CITY OF CONWAY, ARKANSAS HISTORIC DISTRICT COMMISSION

September 28, 2026 • 5:30pm • 1111 Main Street

A. 124, 130, 136 Conway Blvd (HDR-0726-0117) Multi-family development

Old Conway Design Overlay District

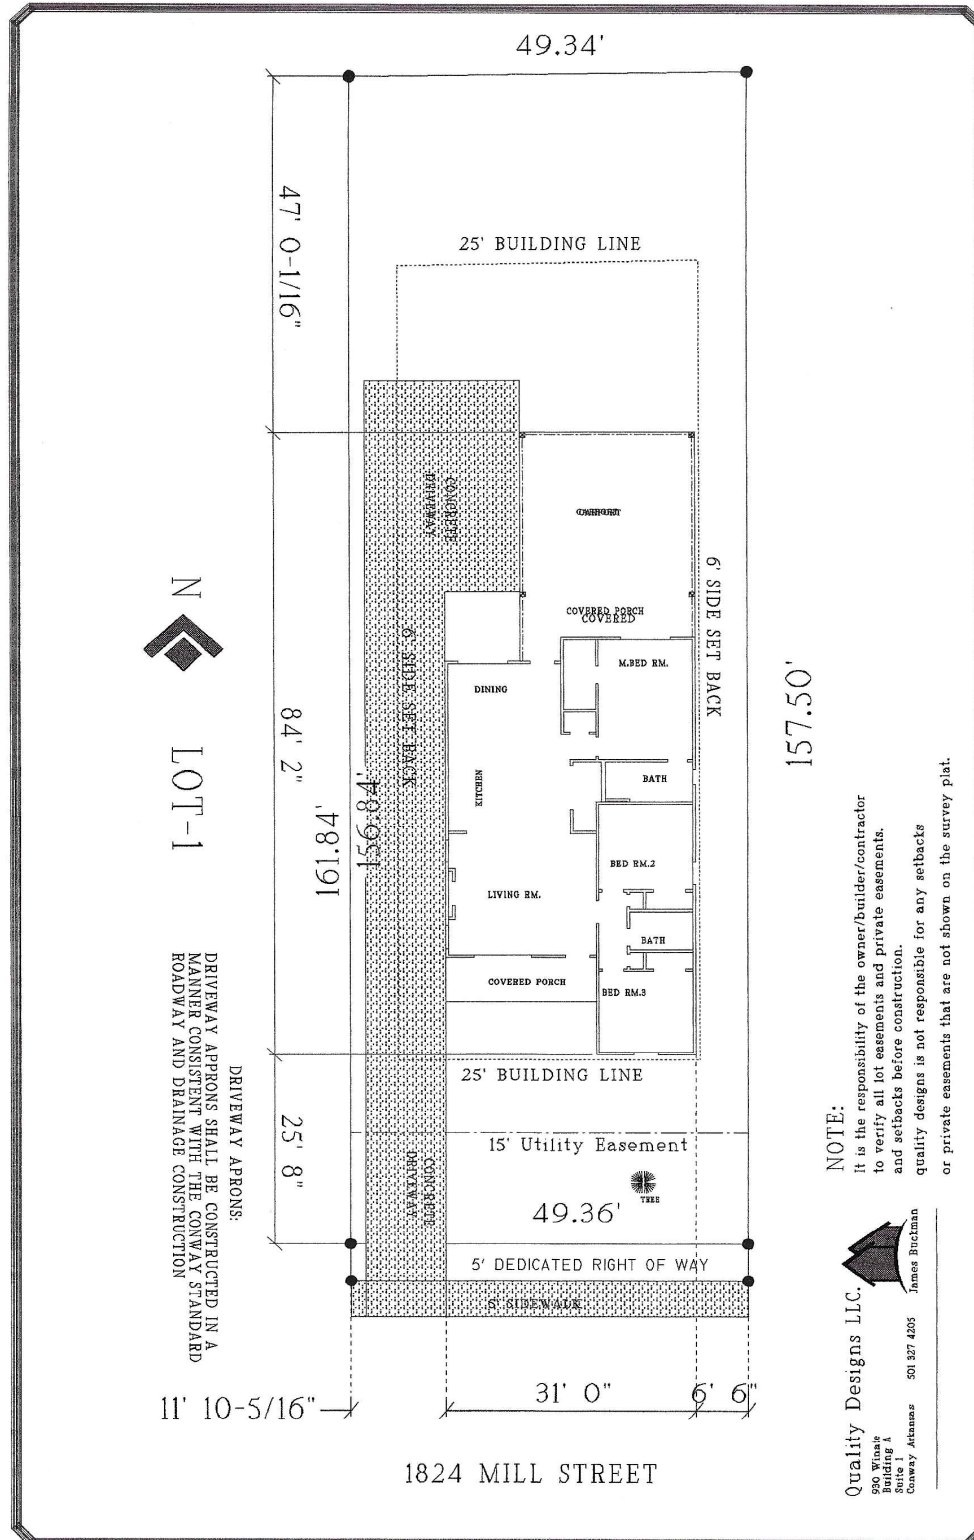
The average front setback for the area is 30', based on five homes on the same block. The applicant must set back the residence between 25' and 35' from the front property line. The applicant is proposing a front setback of 25'8". The proposed structure is 6'6" from the eastern side property line and 11'10-5/16" from the western side property line. The rear setback is 47'. The proposal conforms.

It appears that two trees are vulnerable to removal because of construction. On tree is proposed for planting along the street frontage.

The applicant is proposing a gable roof with architectural shingles. This is compatible with surrounding homes.

1. Applicant must obtain all applicable building permits if/when a Certificate of Appropriateness is granted.
2. Prior to issuance of a Certificate of Appropriateness, the applicant shall provide a site plan showing:

4. One tree shall be planted. If beneath the power line it shall be an understory tree and if away from the power line it shall be a canopy tree. Any significant trees removed must be replaced at a 1:1 ratio.
